The Commission has issued the enclosed Amendment Nos. 91 and 95 to Facility Operating License Nos. DPR-24 and DPR-27 for the Point Beach Nuclear Plant, Unit Nos. 1 and 2. The amendments consist of changes to the Technical Specifications in response to your application dated March 16, 1984 as modified September 25, 1984.

These amendments provide additional restrictions on the movement of heavy loads over the spent fuel pool, changes to position titles within the administrative section of the Technical Specifications (TS) and miscellaneous corrections and editorial changes.

Amendment No. 91
License No. DPR-24

Amendment No. 95
License No. DPR-27

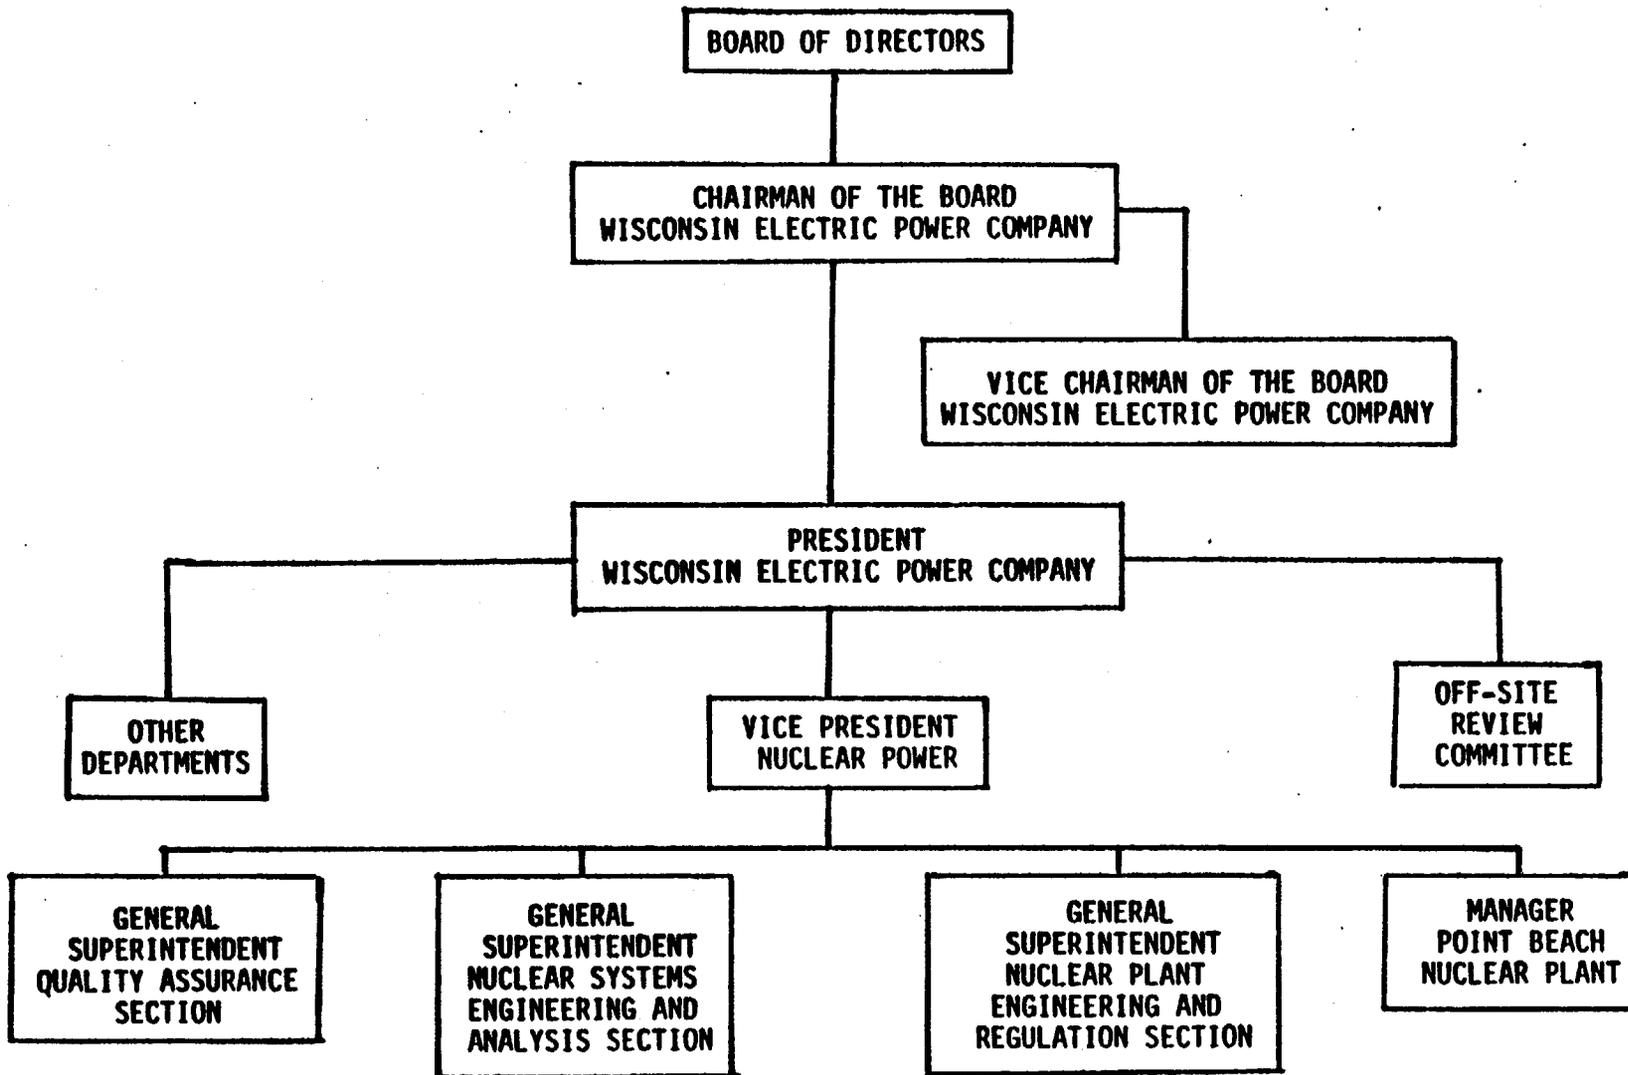
4. Figure 15.6.2-2 - The old position of Shift Supervisor is now designated the Shift Superintendent. This is a title change only and is acceptable.
5. Figure 15.6.2-2 - The minimum shift staffing has been revised to conform to the new shift staffing requirements of 10 CFR 50.54(m). The revisions are, therefore, acceptable.

Figure 15.6.2-1

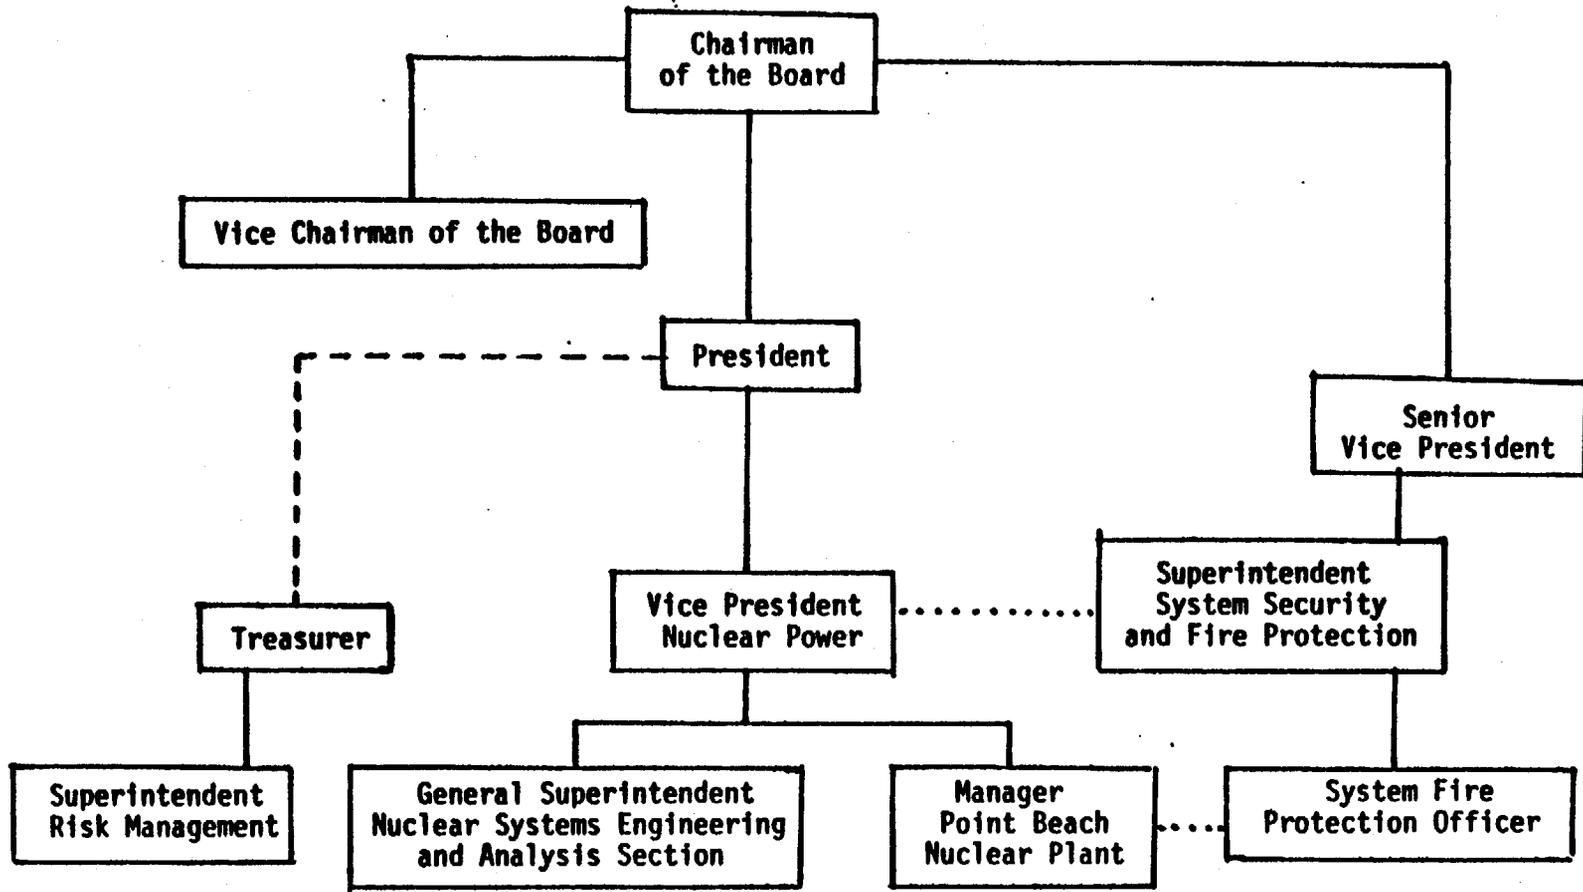
3. Figure 15.6.2-1 - The previous Manager - Nuclear Engineering Section has been replaced by two General Superintendents, one for the Nuclear Systems Engineering and Analysis Section and one for the Nuclear Plant Engineering and Regulation Section. These two General Superintendents are responsible for the same functions previously performed by the Manager - Nuclear Engineering Section. This change allows each General Superintendent to concentrate his attention to particular aspects of the engineering support activity which should result in better engineering support of plant activities. The change does have a potential negative aspect since it results in an increased span of control for the Vice President - Nuclear Power. Under the revised organization, the Vice President will directly supervise the two General Superintendents mentioned above, plus the General Superintendent - Quality Assurance Section and the Manager - Point Beach Nuclear Plant. The staff considers that this span of control is not excessive, however, and thus concludes that the proposed change is acceptable.

Figure 15.6.2-4

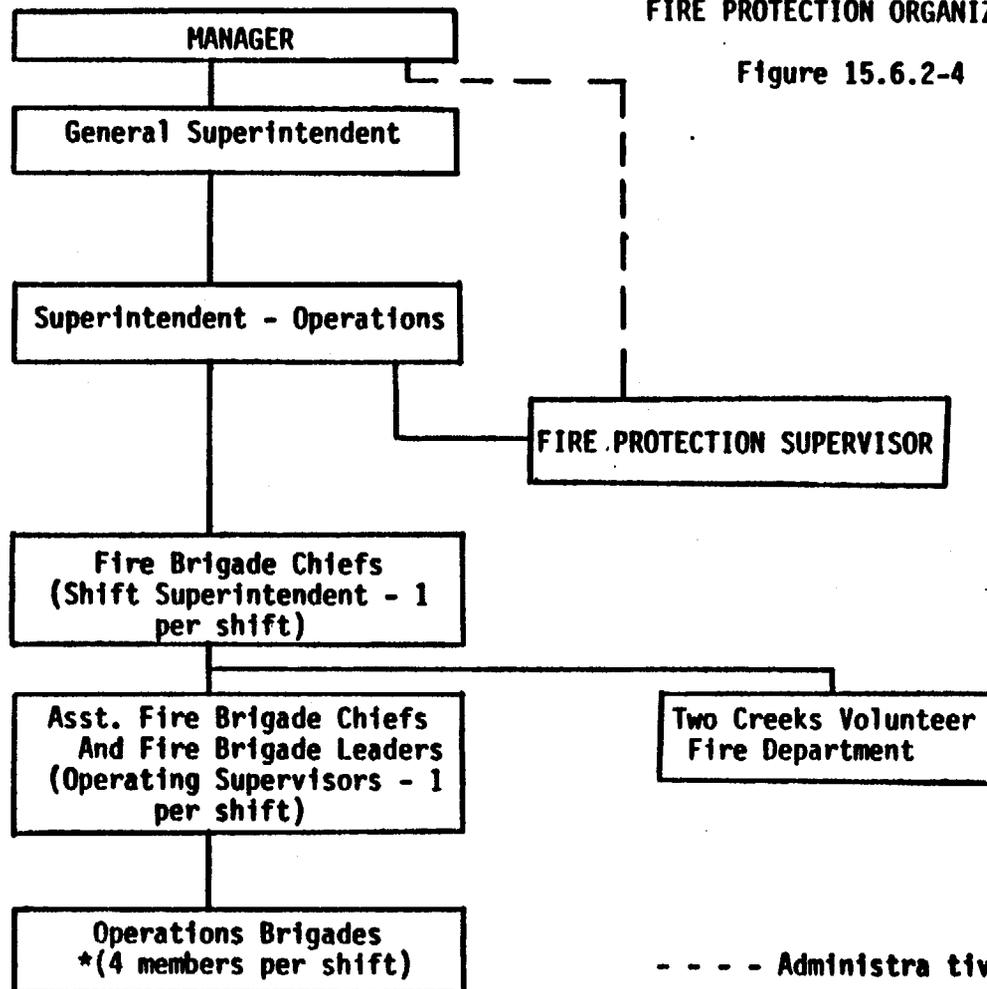
6. Figure 15.6.2-4 - The composition of the fire brigade has been revised to delete the use of one contract security guard as a member. The Point Beach fire protection organization no longer relies on the use of contract security guards. The fire brigade now is composed of either the Shift Superintendent (Fire Brigade Chief) or the Operations Supervisor (Assistant Fire Brigade Chief) and four shift members. Fire brigade membership excludes three members of the minimum shift crew necessary for safe shutdown of the plant and any personnel required for other essential functions during a fire emergency. With this change, the licensee still is in conformance with the requirements for fire brigade membership and for adequate coverage of other plant operations. The change is, therefore, acceptable.
